# Addendum 2

**Date:** August 23, 2017

**Project Name:** Geneva Youth Rehabilitation and Treatment  
Center Fire Alarm

**Project #:** 16116

Drawn	KCK	Project No.	16116
Designed	ACR	Scale	1"=10'-0"
Reviewed	KSB	Date	08/01/2017
Drawing No.	<b>ES1-0</b>

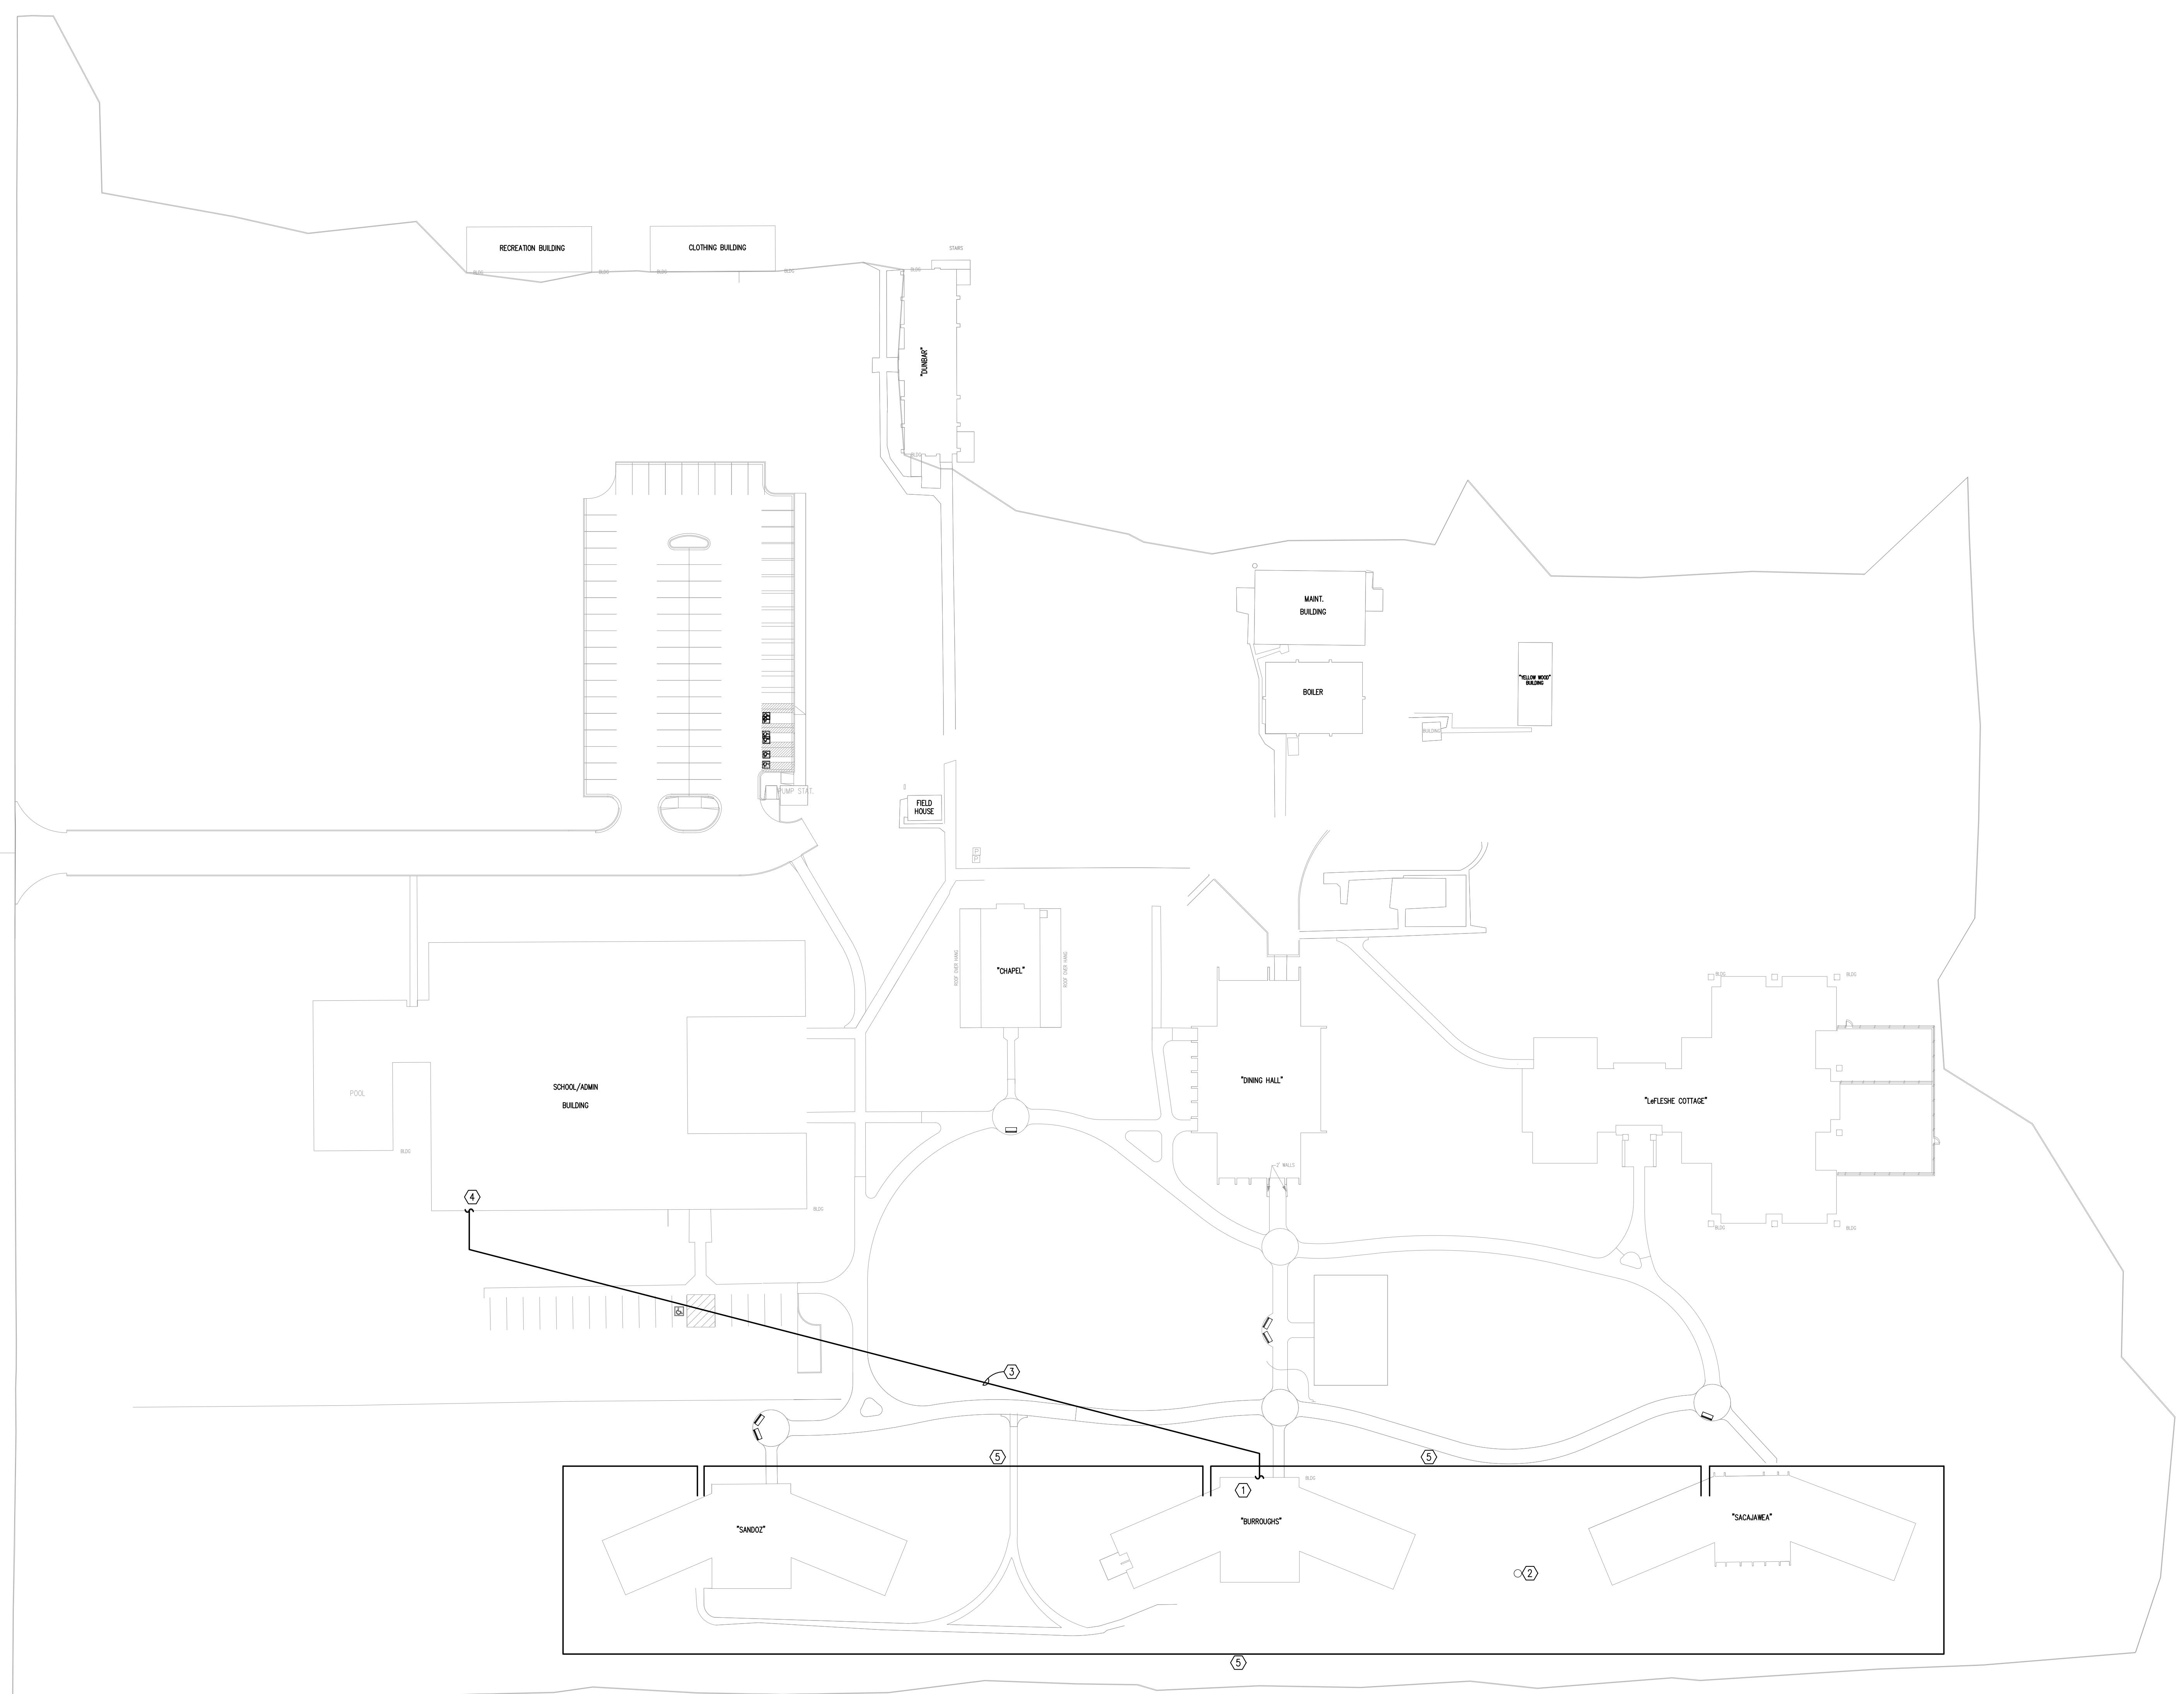
- ED1. Sheet E1-0 Cottage Floor Plans
- A. Add Fire Alarm Annunciator to Sandoz Vestibule
  - B. Clarified Keyed Notes 2 and 8
- ED2. Sheet ES1-0 – Site Plan – Fire Alarm
- A. Added clarification to notes.
